Addendum #3 – Final Core & Shell Package

Project Name: Hudl HQ – New Office / Mixed Use Building
Lincoln, NE
Project No.: 15024
Issued: January 28, 2016
Bid Date: 2:00 PM CST, Tuesday, February 2, 2016
Bid Opening: Sampson Construction
Location: 3730 South 14th Street
Lincoln, NE 68502

Revision to Sheet: **P111**

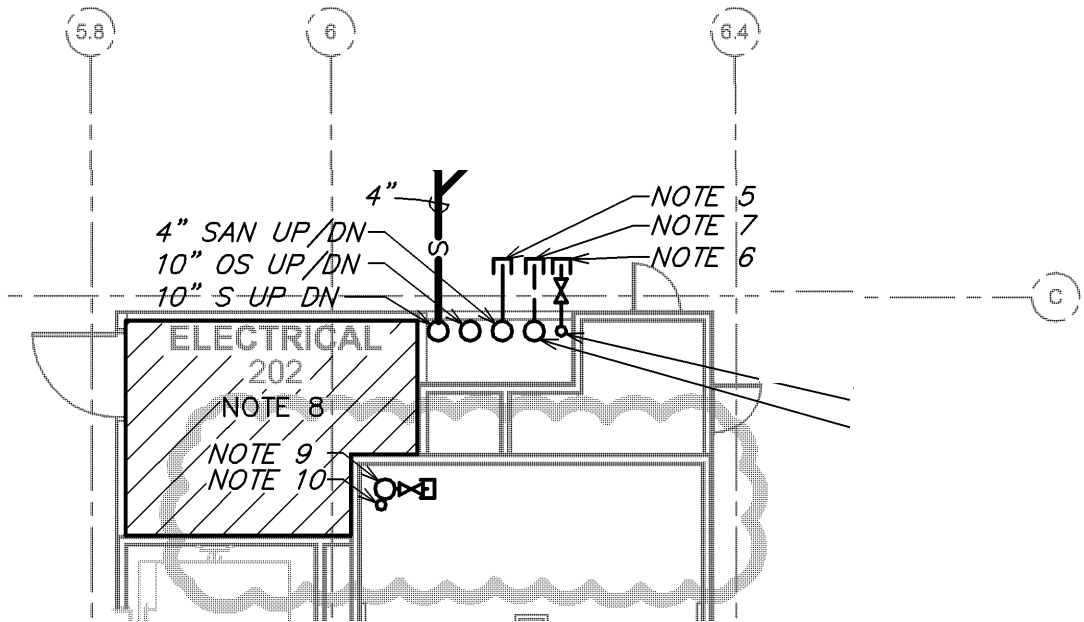
- ADD 3-4.** Revision to P111. Revised plan to include a single fire sprinkler zone control assembly. Refer to **Attachment P3-1.**
- ADD 3-5.** Revision to P112. Revised plan to include a single fire sprinkler zone control assembly. Refer to **Attachment P3-2.**

Revision to Sheet: **P113**

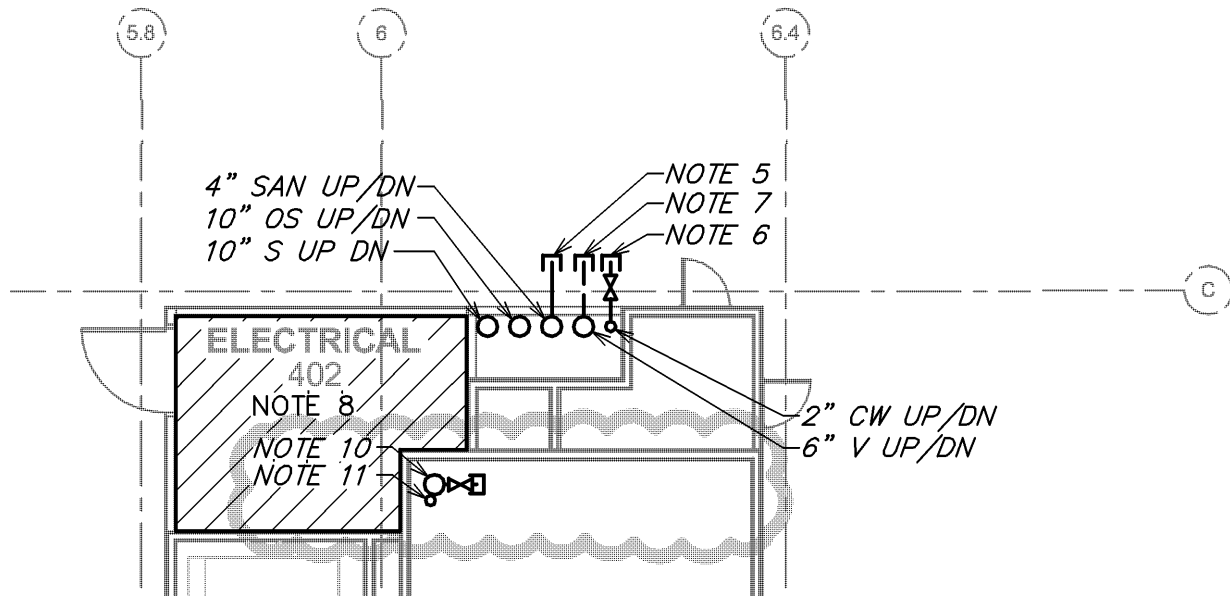
- ADD 3-6.** Revision to P113. Revised plan to include a single fire sprinkler zone control assembly. Refer to **Attachment P3-3.**
- ADD 3-7.** Revision to P114. Revised plan to include a single fire sprinkler zone control assembly. Refer to **Attachment P3-4.**

Revision to Sheet: **P115**

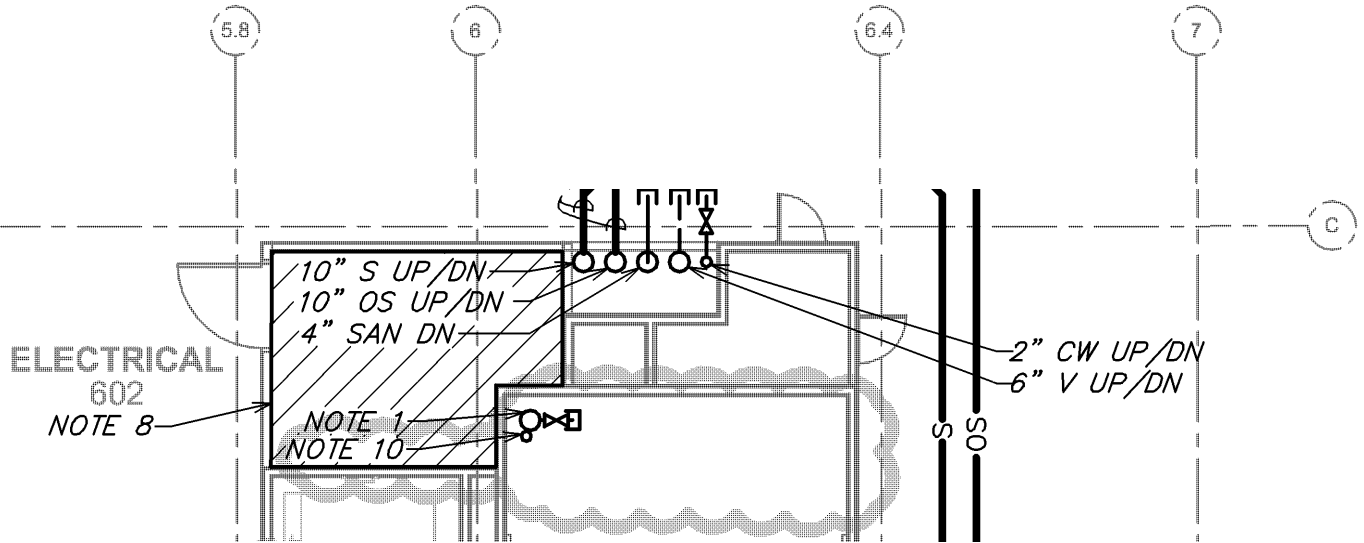
- ADD 3-8.** Revision to P115. Revised plan to include a single fire sprinkler zone control assembly. Refer to **Attachment P3-5.**
- ADD 3-9.** Revision to P116. Revised plan to include a single fire sprinkler zone control assembly. Refer to **Attachment P3-6.**
